WATER QUALITY MEMORANDUM

Utah Coal Regulatory Program

SUBJECT: Second Quarter of 2013 Water Monitoring, Andalex Resources, Centennial Mine, C/007/0019, Task ID #4340

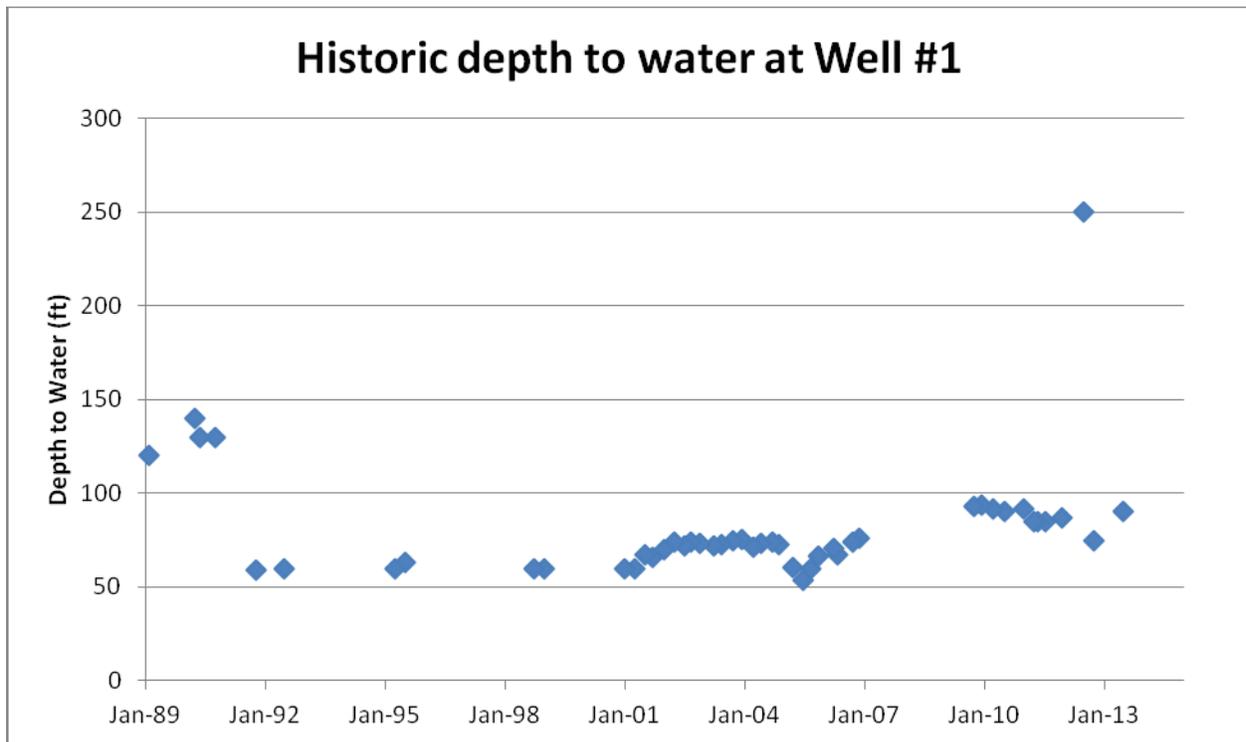
None. The last depth to water level measured 90 feet, which appears to be consistent with data from previous year's seasonal data. The 250 reading from Second Quarter of 2012 appears to have been an erroneous measurement.

The continued examination of the depth to water at Well #1 is required.
